NUMBER 48

BULLETIN

SUBJECT: MUFFLERS: 1. Failure of Inner-Baffle End Attachments
2. Inspection
3. Remedial Measures for Preventing Engine Failure

MODELS AFFECTED: J4A and J4F, Serial Nos. 4-828 to 4-1384 inclusive
(EXCLUDING 4-1372)

MUFFLER BAFFLE SUPPORT

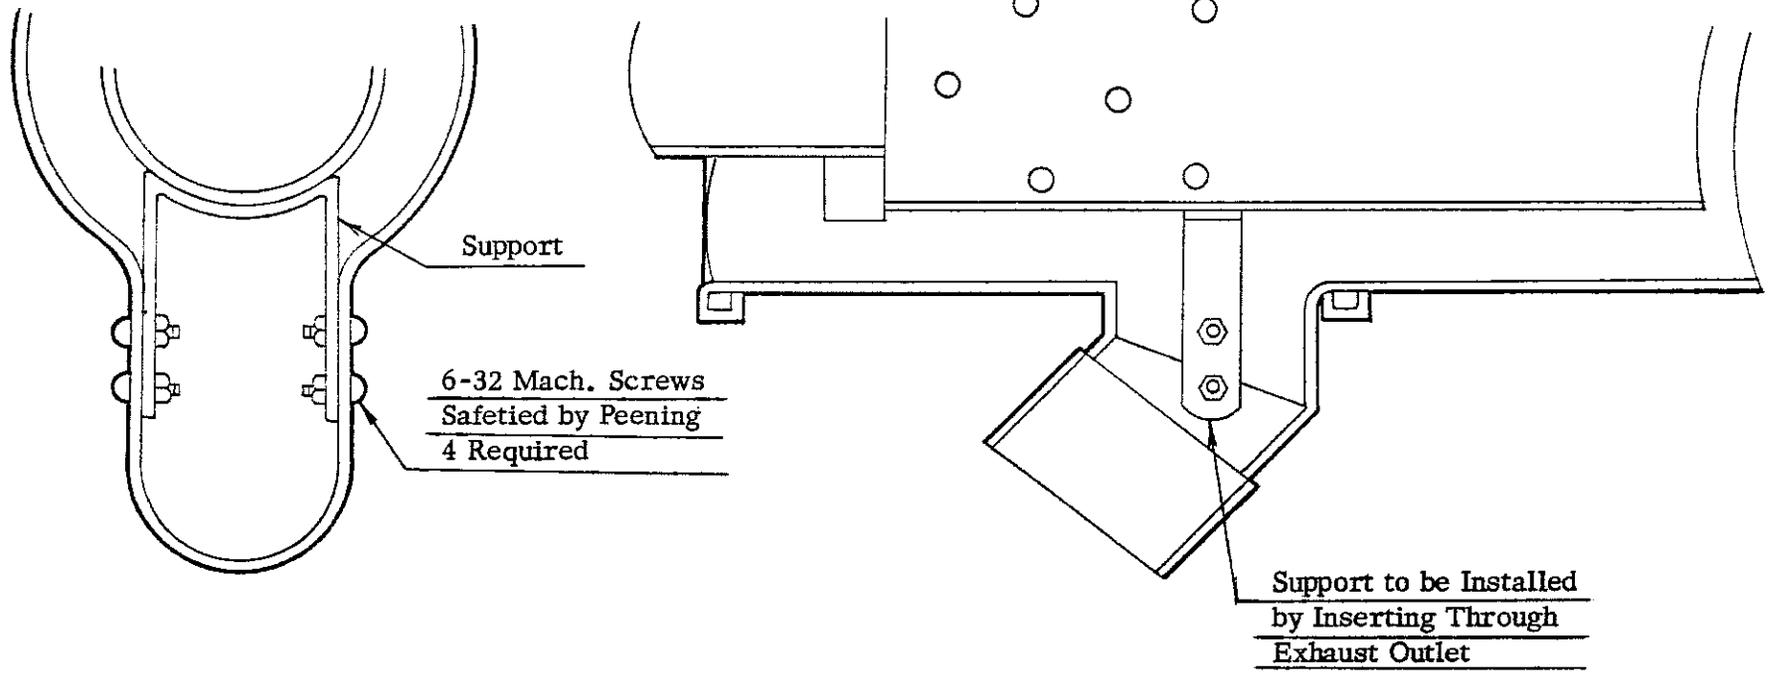
However, if the muffler is found to be satisfactory, the enclosed support clip must be installed immediately per the instructions on the attached sketch in order to prevent the inner baffle from covering the exhaust outlet if the end attachments should fail sometime in the future.

Inner Baffle to be Inspected
Through Exhaust Outlet for
Loose End Connections

If upon inspection the inner baffle is found to be loose, the muffler assembly should be replaced by an improved type muffler, Part No. A7236. Mufflers for replacement may be obtained at manufacturing costs by contacting your local dealer or distributor.
